Intersection ID: 8650	Main Street: GARNETTE_PL	Cross Street: ST_MARK_ST	Location:	NW
ADA ID: 049A06A70653	Ramp Type: BlendTrans2	Initial Pass/Fail: Fail	Overall Compliance: No	Severity Score: 21.25

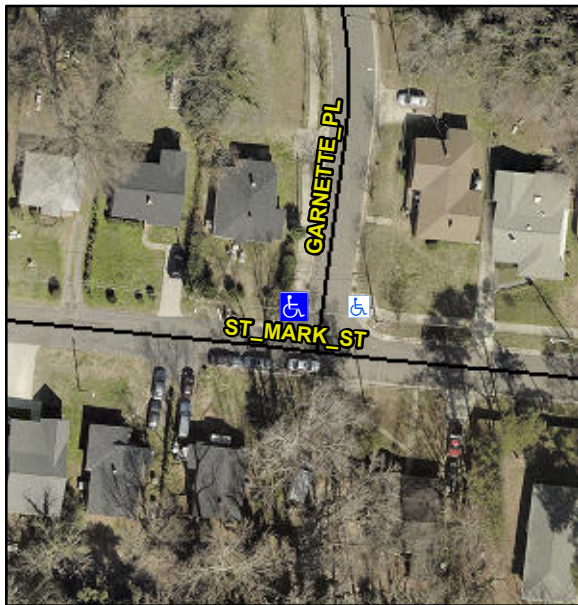
**VEGETATION OVERGROWTH, NO  
LT SW**

**Not Found, R304.5.1, R304.5.3**

**Remove & Replace Curb Ramp With Two New Directional Ramps or Equivalent.**
